Determination 2018/014

The refusal of a code compliance certificate for alterations to a house at 13 Clifford Street, Gisborne

Figure 1: Floor plan of alterations

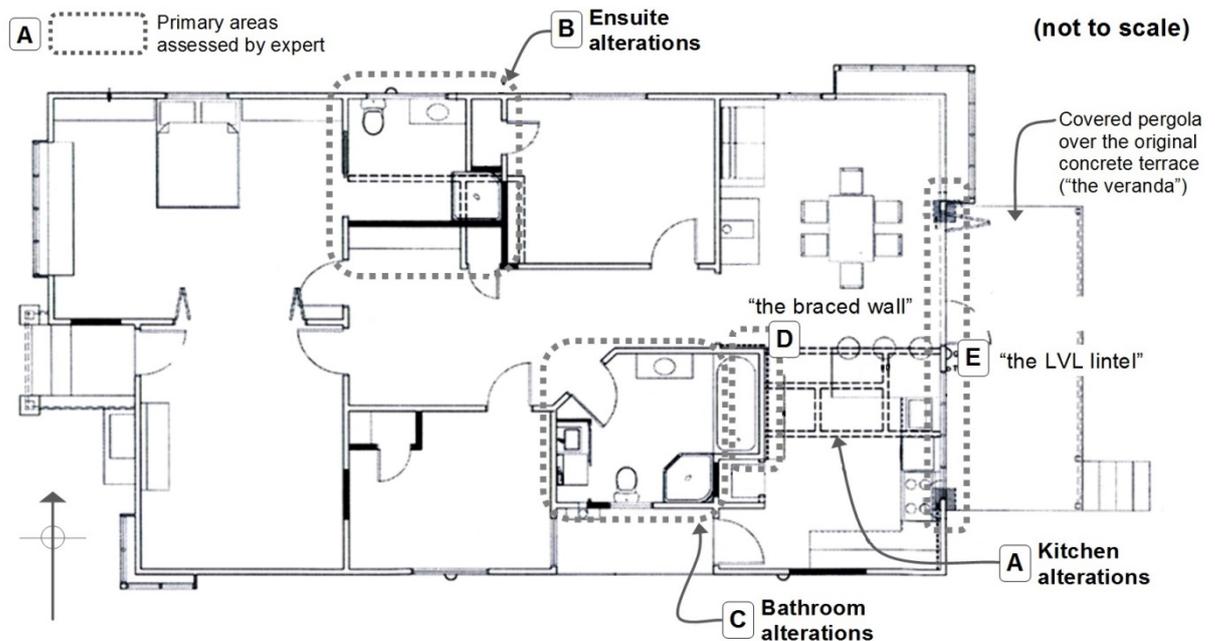
- 3.2.5 The engineer's review addressed the absence of the plywood bracing element noted by the expert (see paragraph 4.6.1) but the review made no comment on the remaining matter being the lack of a connection to the bottom of the LVL lintel beam (Area E on Figure 1).

4.3.3 In regard to the braced wall (Area D), the expert noted that:

- the drawings called for the corner walls around the north east sides of the bathtub to be braced on the kitchen/dining side with 12mm plywood sheets

- drilling through lining at the corner of the wall revealed rimu drillings, with no evidence the plywood had been installed

4.3.4 In regard to the LVL lintel (Area E), the expert noted that:

- the old joinery was removed, with a 5.3m lintel installed over the opening for the kitchen window and the dining bi-fold door
- the large original concrete pad at the SE corner is close to, but not directly beneath the south support studs to the lintel opening
- the original foundations support two 90 x 45mm studs under the lintel end in lieu of a 90 x 90mm post fixed to a new concrete pad with stainless steel brackets anchored into the concrete
- removal of a small section of lining beside the north end of the door sill revealed a galvanised angle bracket bolted through double studs and fixed with coach screws through the bottom plate into underlying timber, with no connection extending into the concrete foundation wall.

- plywood sheet bracing has not been installed to the braced wall (Area D)
- galvanised angle brackets to the lintel support studs do not connect to original concrete foundations (Area E).

- the lack of plywood installed to the braced wall (Area D)
- the structural connections of the bottom of lintel support studs (Area E)
- the unsealed junctions at the:
 - jamb facings to the kitchen window (Area E)
 - bathroom water heater junctions with the weatherboards
 - ensuite toilet drain pipe penetration through the weatherboards (Area B)
- the lack of sealing to the ensuite shower fittings (Area B)
- the ensuite extract fan is not vented to the outside (Area B)
- the lack of a grate to the gully trap outside the ensuite (Area B)
- the apparent lack of a terminal vent to the foul water drain.

- 5.3.2 The review highlighted the even distribution of the lined walls capable of resisting horizontal loads throughout the building, and the redundancy along most bracing lines. The exception to this is the eastern exterior wall which is reliant on one bracing element at the south end of the eastern wall. However, the expert raised no concerns about this particular bracing element.
- 5.3.3 I consider further engineering assessment and verification is required in respect of the connections at the bottom of lintel support studs (Area E) in order to satisfy the compliance of the structure with Clause B1 Structure.

- 5.4.1 Pending engineering investigation and confirmation, I am unable to conclude whether the north east bathroom/dining wall and the connections at the bottom of lintel support studs comply with Clause B1 of the Building Code.
- 5.4.2 The alterations are required to comply with the durability requirements of Clause B2, which require the altered areas to satisfy all the objectives of the Building Code throughout their effective life. The durability requirements of Clause B2 include a requirement for wall claddings and wet area linings to protect the underlying framing

- 5.3.4 I conclude that investigation and/or remedial work is necessary in respect of the following areas:
- In regard to Clause E2, the unsealed junctions at the:
 - jamb facings to the kitchen window (Area E)
 - bathroom water heater junctions with the wall cladding
 - ensuite toilet drain pipe penetration through the wall cladding (Area B)
 - In regard to Clause E3:
 - the unsealed ensuite shower fittings (Area B)
 - the lack of ducting to the outside of the ensuite extract fan (Area B)
 - deteriorating sealants to some junctions
 - In regard to Clause G4:
 - the ensuite extract fan does not appear to be vented to the outside
 - In regard to Clause G13:
 - verification of an open terminal vent to the foul water drain
 - the lack of a grate to the gully trap outside the ensuite.

- the unsealed cladding penetrations and external jamb facing boards do not comply with Clause E2 External moisture of the Building Code
- the unsealed shower fittings, and deteriorating sealants do not comply with Clause E3 Internal moisture of the Building Code
- the extract fan to the ensuite does not vent to the exterior and does not comply with Clause G4 Ventilation of the Building Code
- the lack of a grate to the ensuite gully trap does not comply with Clause G13 Foul water of the Building Code
